8x930Ax (8x930AD, 8x930AE) SPECIFICATION UPDATE

Release Date: February 1997

Order Number: 272940-008

The 8x930Ax may contain design defects or errors known as errata. Characterized errata that may cause the 8x930Ax's behavior to deviate from published specifications are documented in this specification update.

Figure 2. External Code Fetch, Nonpage Mode

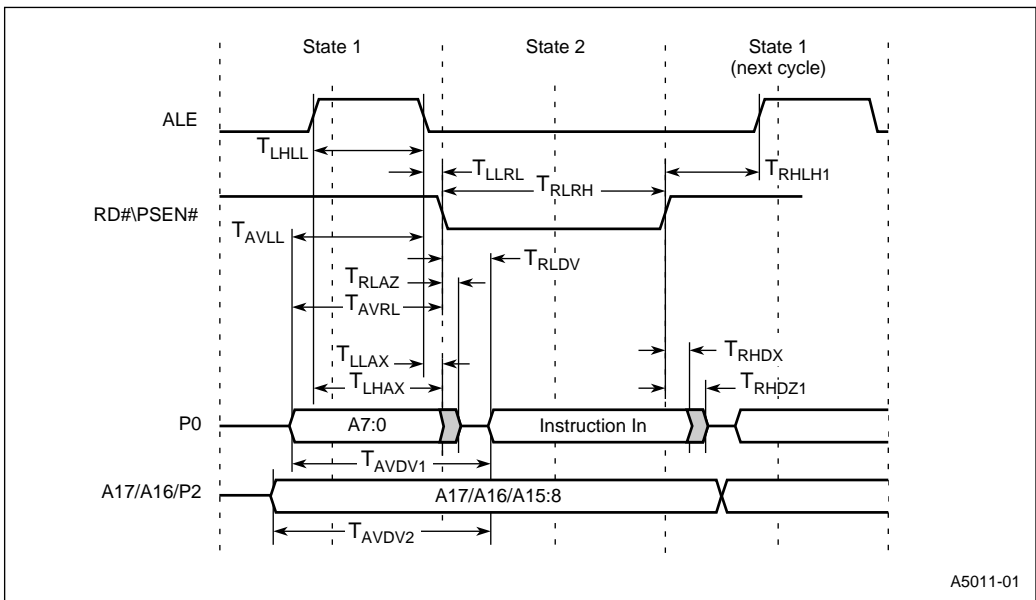
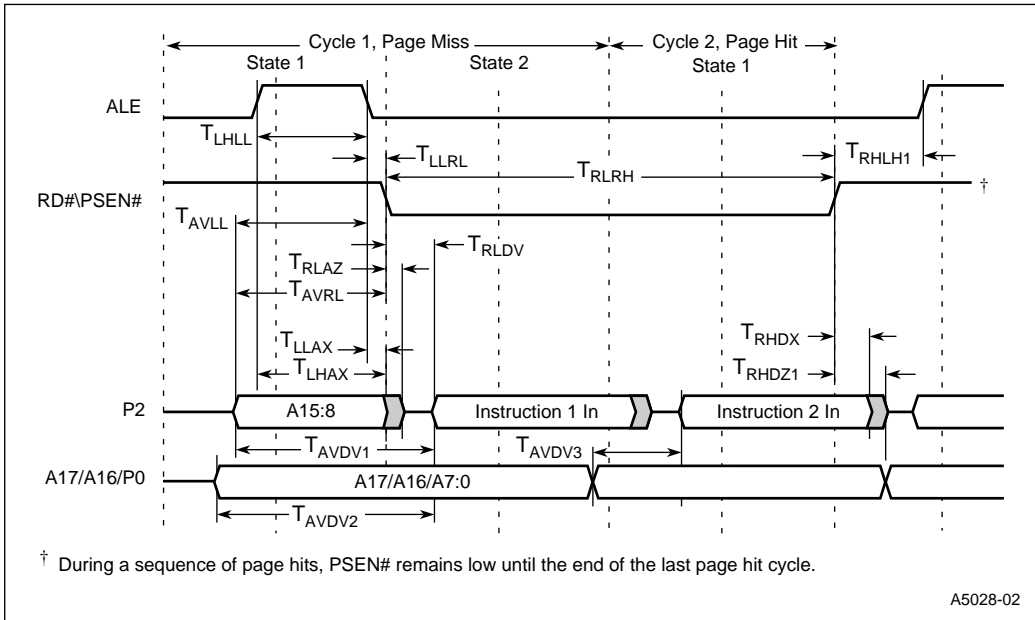
PROBLEM: The T_{RHDZ1} (Instruction Float After RD#/PSEN# High) specification on the 8x930Ax when operating at 12 MHz is 10 ns. However, a slow memory device such as an EPROM typically takes approximately 30 – 90 ns to float its output. (This specification, generically called T_{PHZ} , may vary depending on the memory type and manufacturer.) Figure 2 and Figure 3 illustrate the T_{RHDZ1} timing.

The difference between the T_{RHDZ1} and T_{PHZ} specifications causes contention on the data bus (P0 in nonpage page, P2 in page mode). The 8X930Ax begins to drive the address for the next bus cycle while the memory device is still driving data from the previous bus cycle.

To prevent this contention, designers can use a buffer to isolate the output of the memory device from the data bus (port 0 or port 2) of the 8x930Ax. This will prevent the memory device from driving the data bus during the critical period after T_{RHDZ1} expires. We suggest a buffer such as the 74F541 octal, three-state line driver shown in Figure 4.

Figure 4. Example Bus Contention Solution for 8X930Ax (Nonpage Mode)

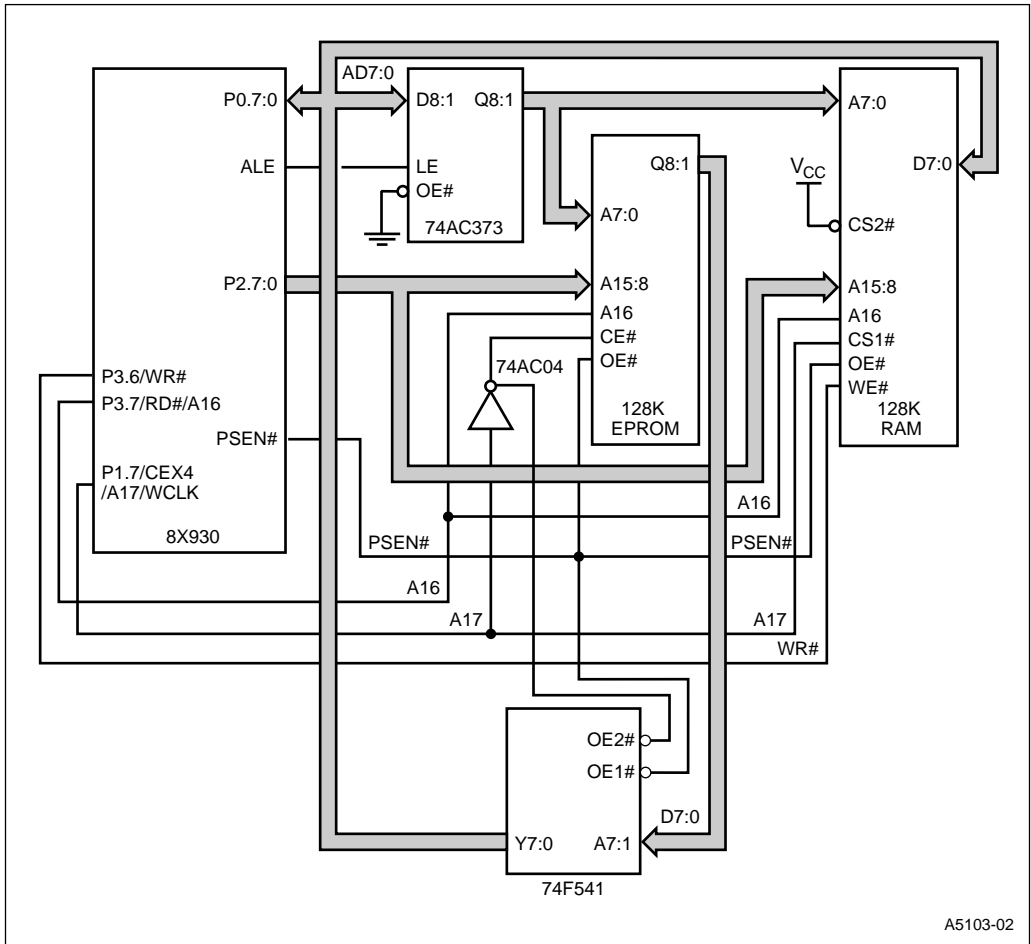
Figure 4 illustrates the connections of an 8X930Ax configured for nonpage mode with EPROM and RAM in external memory. If your system uses a different configuration, your circuit will be different from the example. The 74F541 is enabled to pass data from the EPROM to the 8X930Ax (port 0) when OE1# and OE2# are active. Table 2 is a truth table for the 74F541.

During a read, PSEN# turns the buffer on (OE1# and OE2# are active), connecting the EPROM's output to the 8X930Ax's port 0.

When PSEN# goes high after a read, OE1# and OE2# are deasserted, and the buffer's output switches to the high-impedance state in approximately 9.5 ns (T_{PHZ} for a typical 74F541; the value may vary from one manufacturer to another). Thus, contention on the data bus is prevented. This or a similar hardware solution is recommended for 8X930Ax designs in which memory devices do not meet the T_{RHDZ1} timing specification.
